June 8, 2026

2025-CRW-1028

Re: Addendum No. One (1)
Electric Charging Station
West Virginia International Yeager Airport (CRW)

CE100

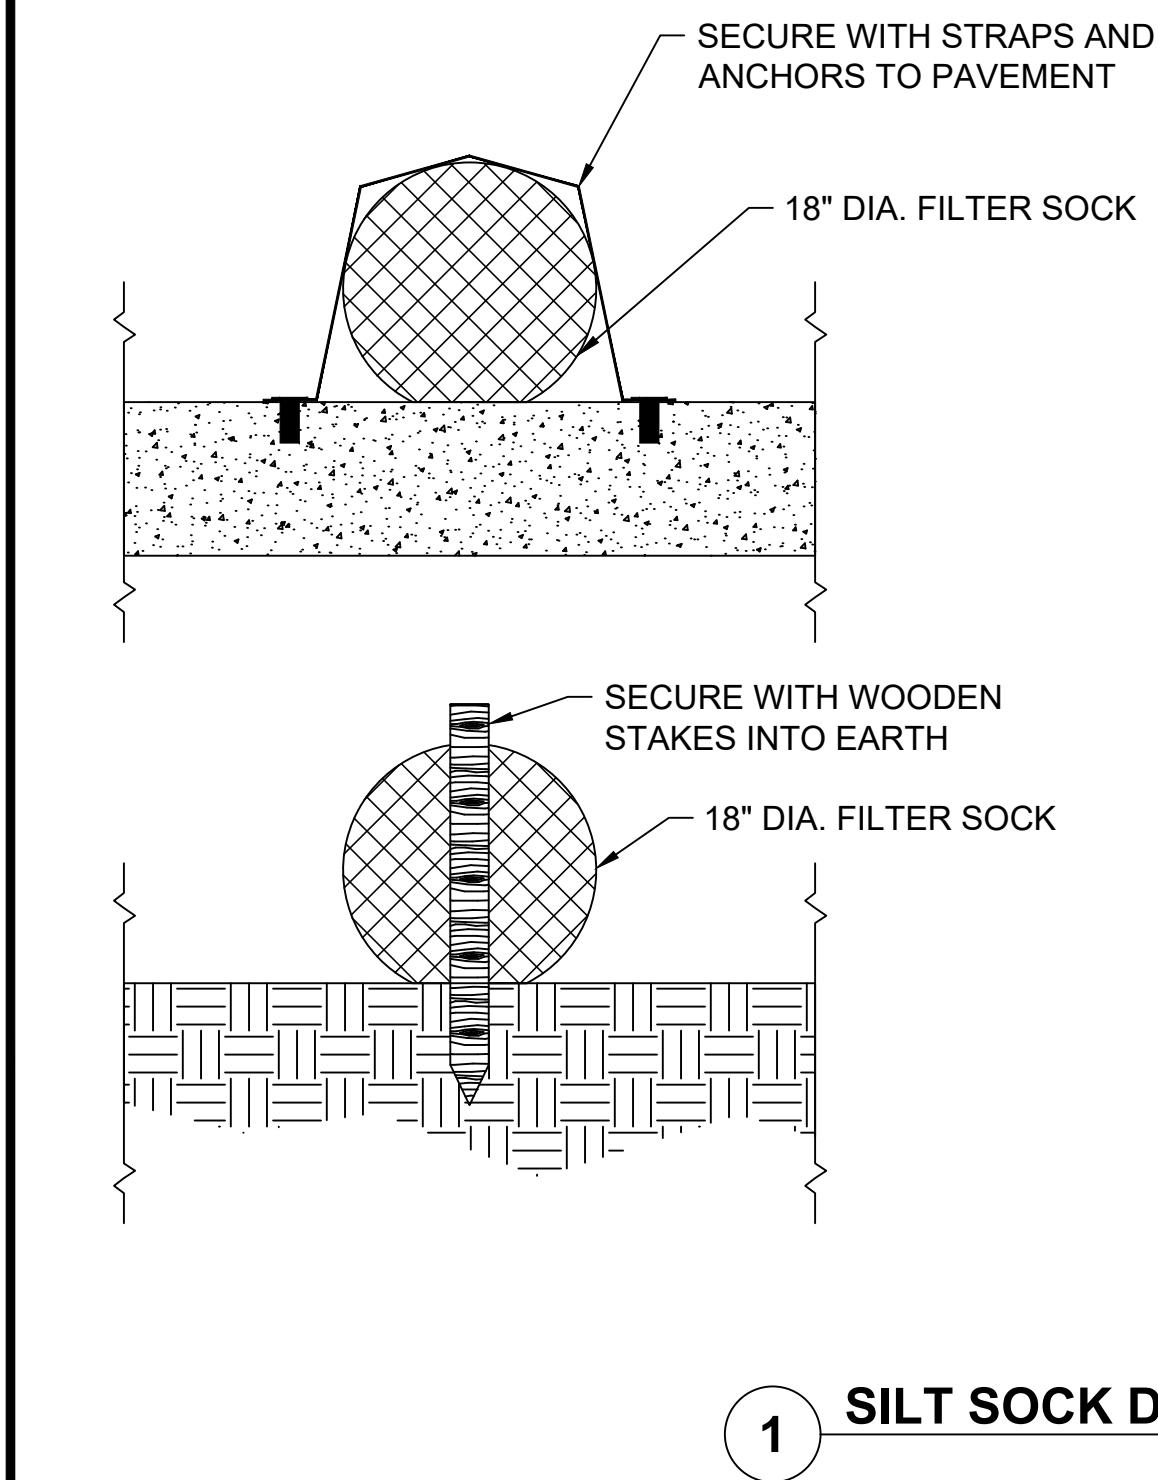
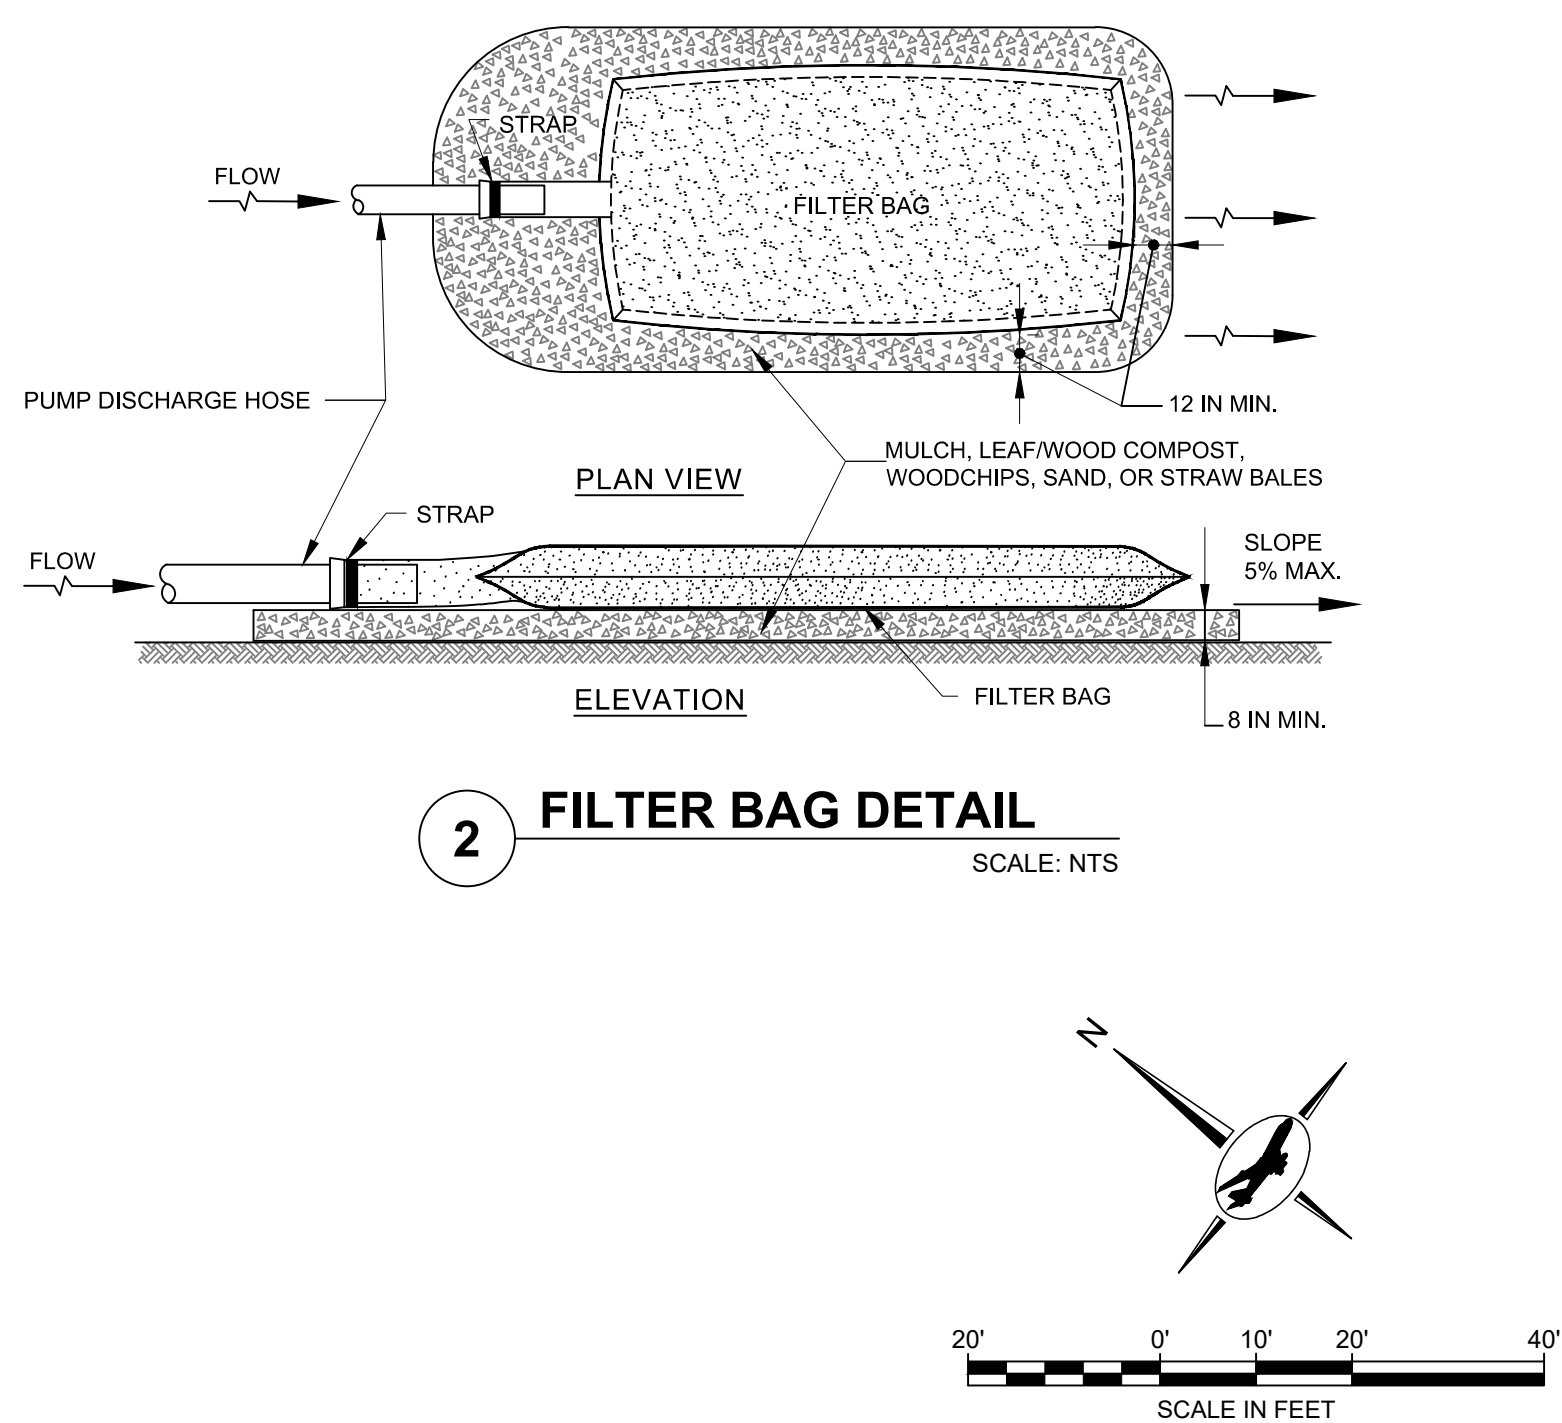
- 1.10.1 **REMOVE** Silt Sock crossing Eagle Mountain Road
- 1.10.2 **REVISE** Silt Sock to properly protect new ductbank installation around proposed connection to existing utilities
